Van's RV-10 Service Bulletin

RAA

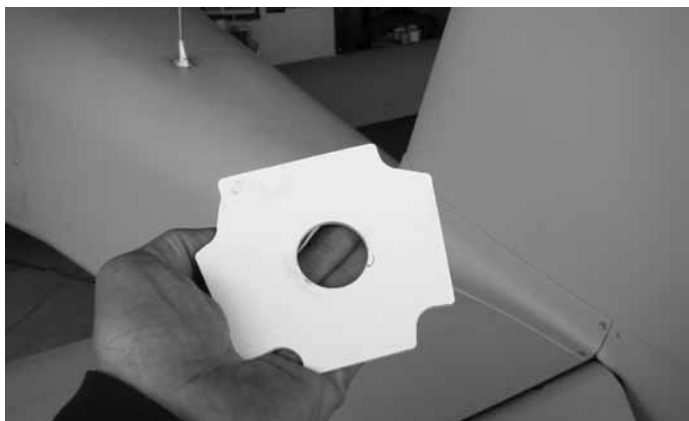
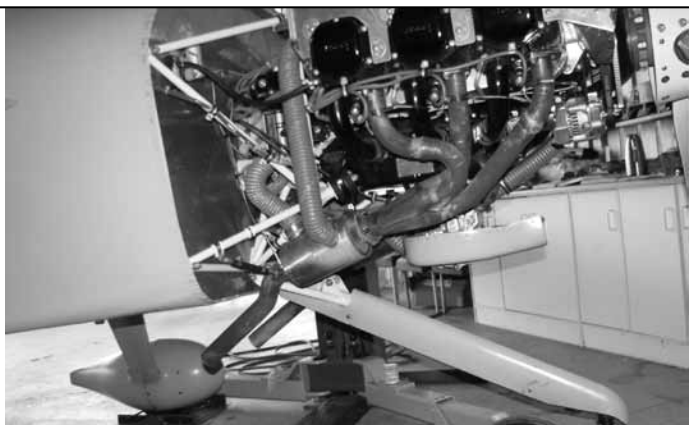
The procedure is to take the load off the nosegear by tying the tail down so that the shock absorber unit may be removed. A careful inspection of the socket of the engine mount is to be carried out, and for this the powder coat paint may have to be removed either by abrasion or by the use of a chemical paint stripper. In some cases there will be cracks emanating from the centre hole that accepts the top end of the shock absorber unit. To date this has happened only to aircraft that have had rough field operations.

If there are no cracks the procedure is to slip the Vans-supplied doubler plate over the top of the shock absorber unit and reinstall everything. The plate is thick enough to spread the bump loads to the edges of the socket in the engine mount.

There is a second check to be done at this point. With the shock installed the owner must check for vertical play that can occur as a result of wear on the elastomeric donuts of the shock assembly. If more than 3 washers are required to remove the play the donuts must be replaced with new. The whole procedure should take only half a day.

If there are cracks the engine and mount must be removed to have Vans-supplied reinforcement pieces welded in place to reinforce the socket. For most owners this will mean that the mount must be removed from the engine to be sent out for "precision welding".

Although Vans does not specify the method it would be foolish to use a wire feed welder, either with or without argon gas. Vans specifies that ER70 S-2 filler rod must be used. This is the rod commonly used when TIG or oxyacetylene welding, and every welding supply will stock it.

As before, when installing the shock no more than 3 washers may be used to eliminate play, or the elastomeric donuts must be replaced with new.
